**Norwood Young America Planning Commission**  
**6:00 p.m., Tuesday, August 6, 2024**  
**Norwood Young America City Council Chambers, 310 Elm St. W.**  
**AGENDA**

REQUEST: Four variances to facilitate the construction of an accessory structure at 10 2<sup>nd</sup> St. SE.

REQUEST: Preliminary & final plat, conditional use permit, variances and site plan approval to facilitate the development of a new facility for Nordic Waste and C&C Lawns in TWIP2.

Sheet #2 updated 7-17-24

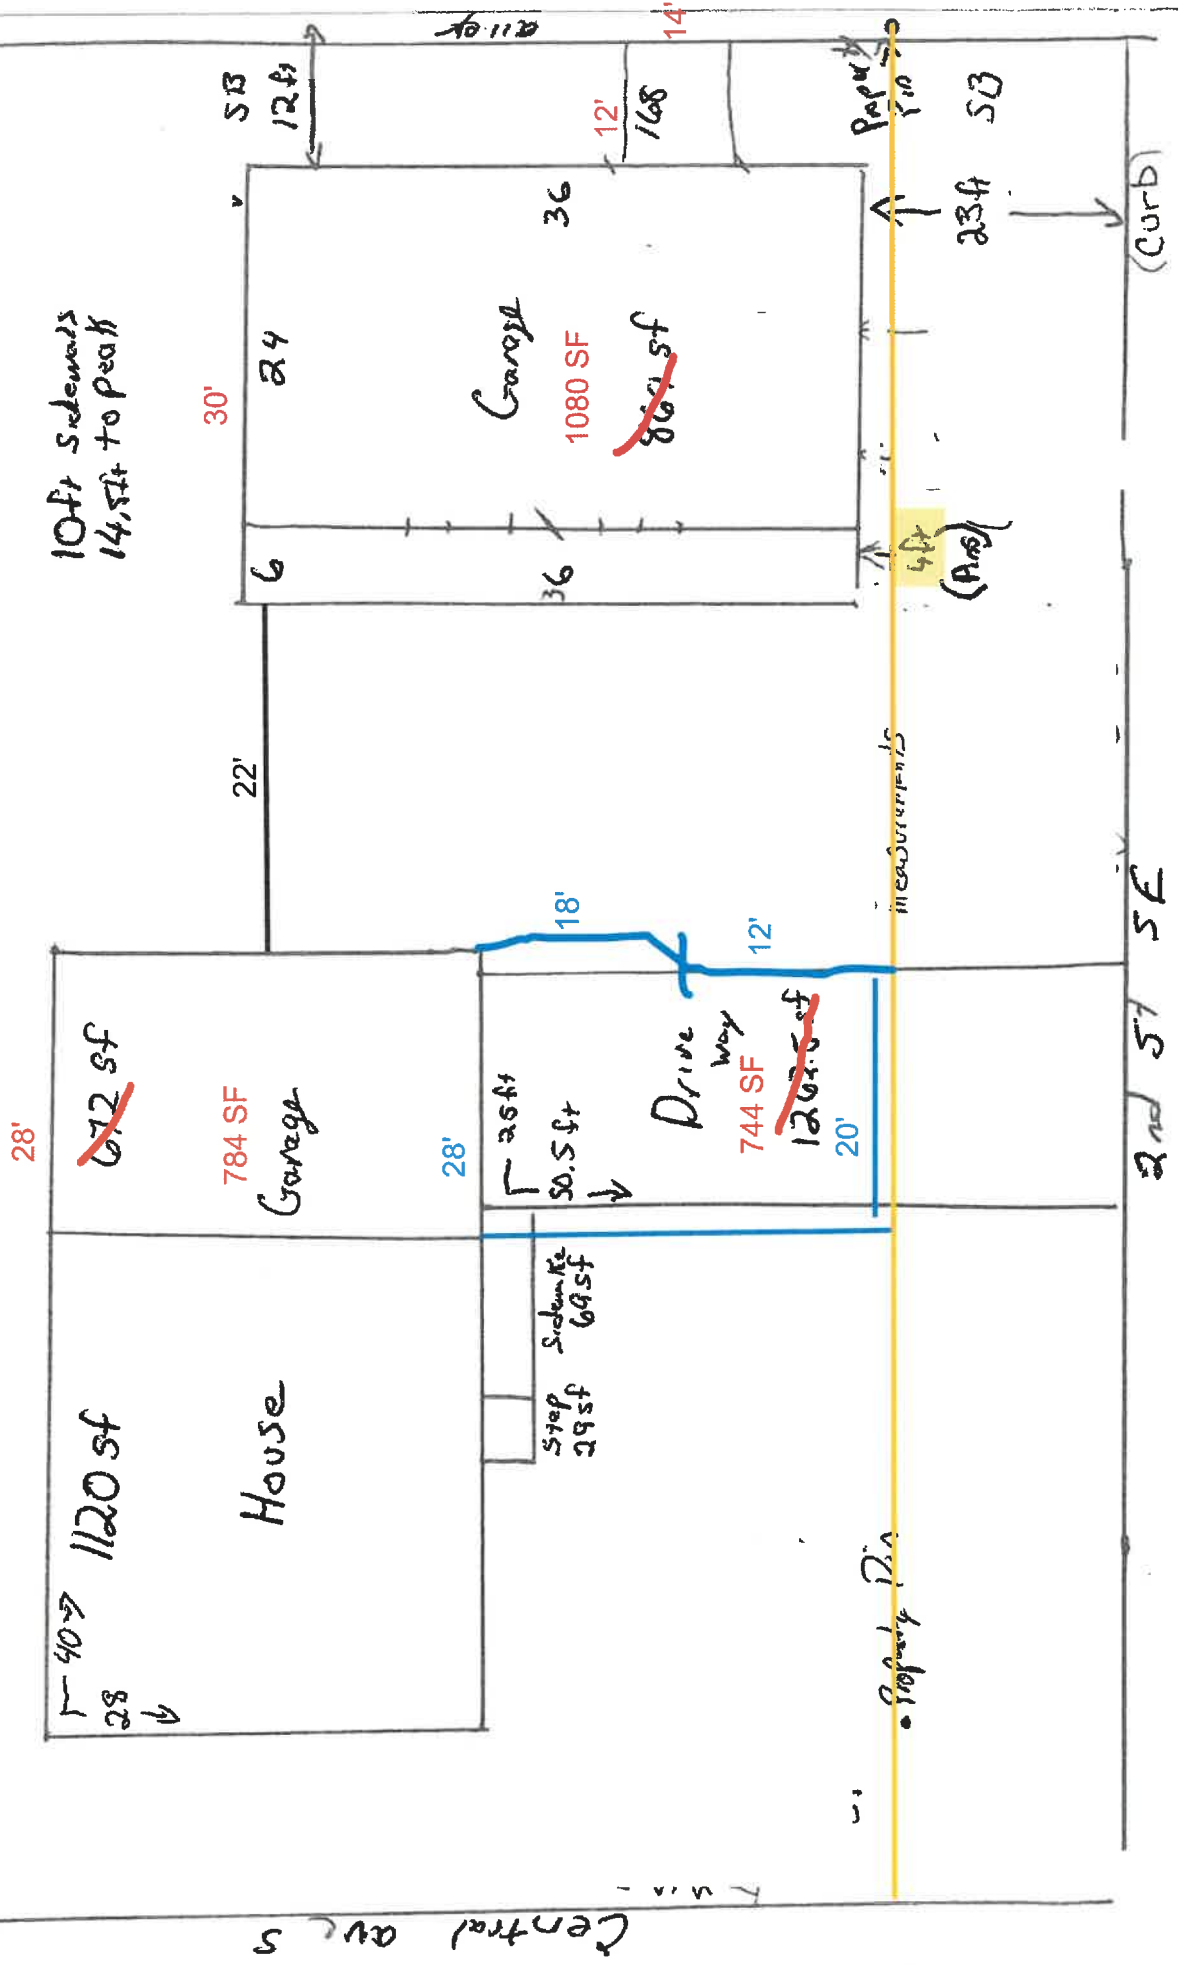
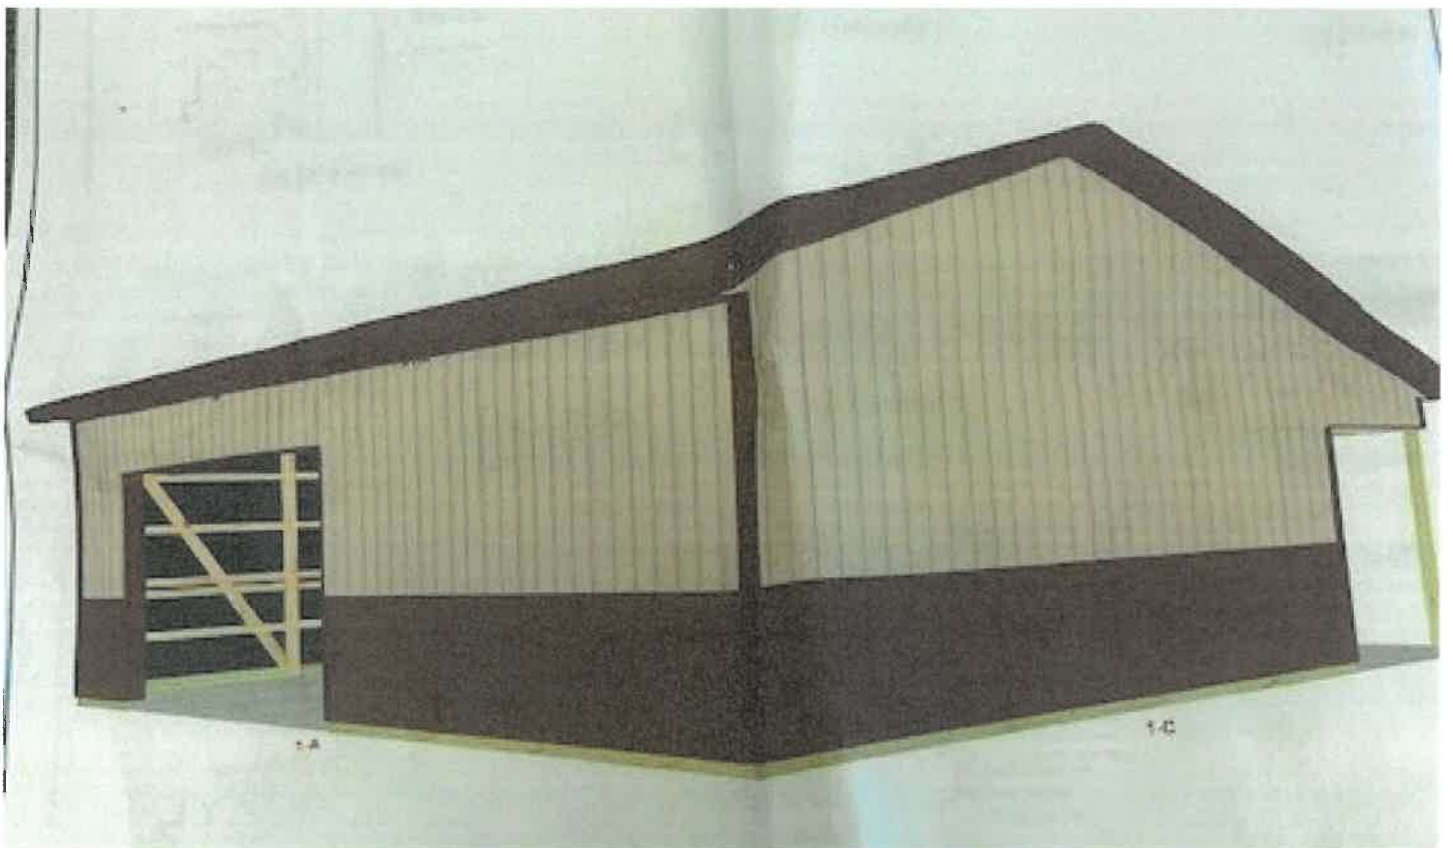
**Conclusions:** Three of the four variance requests (excluding the height request) could have been avoided had the Applicant reviewed the Zoning Code or approached the City to discuss his plans prior to commencing construction. Fairly minor alterations to the proposed size and location of the structure could meet ordinance

Based on the information in the submitted application and findings in this report, staff recommends that the Planning Commission **recommend denial** of the requested variances, based on the proposed structure not satisfying all required variance criteria.
